Summary of Comments on Serial Attached SCSI - 2 (SAS-2) Standard

Figure 160 — SP (phy layer) state machine - SATA host emulation states

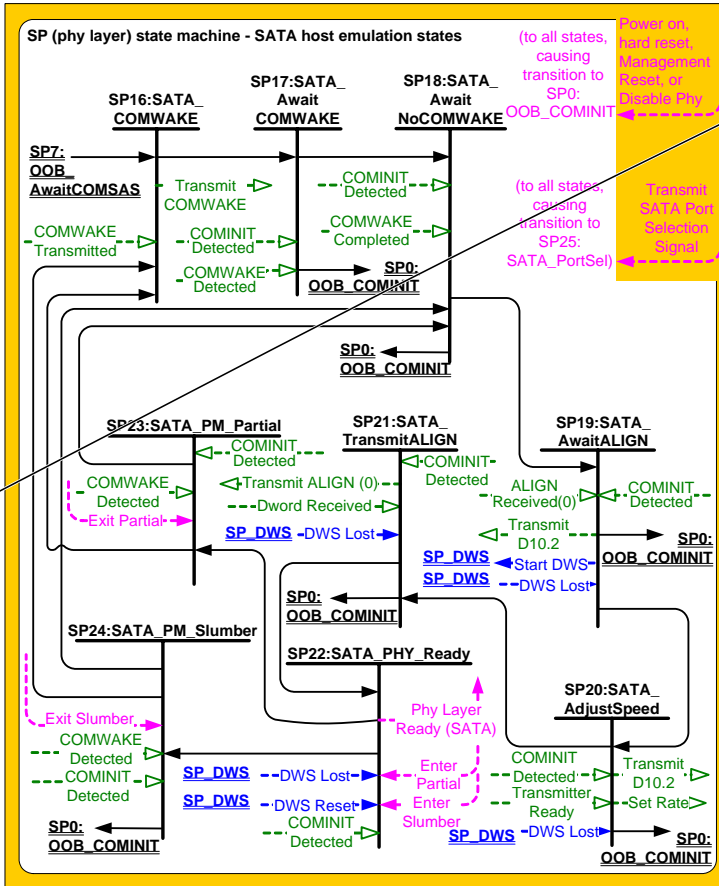
Author: George Penokie Subject: Sticky Note Date: 8/26/2008 2:32:04 PM
That is nothing in the STP section about Slumber and Partial. This is probably OK for SAS 2 but this could get confusing when SSP starts doing the same kind of functions using the same names. Perhaps we should rename all these to SATA_Partial and SATA_Slumber.

Figure 222 — MT_TP (transport layer for SMP target ports) state machine

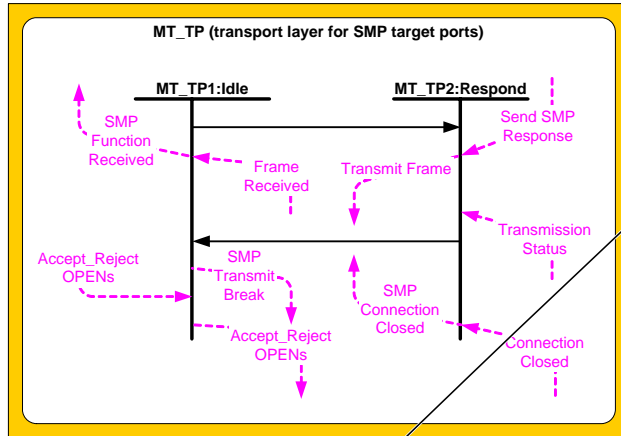
Author: George Penokie Subject: Highlight Date: 8/13/2008 3:02:39 PM
 Frame Received (normal) confirmation

Author: George Penokie Subject: Highlight Date: 8/13/2008 3:03:00 PM
 Frame Received (normal) confirmation

Author: George Penokie Subject: Highlight Date: 8/13/2008 3:03:16 PM
 Frame Received (normal) confirmation
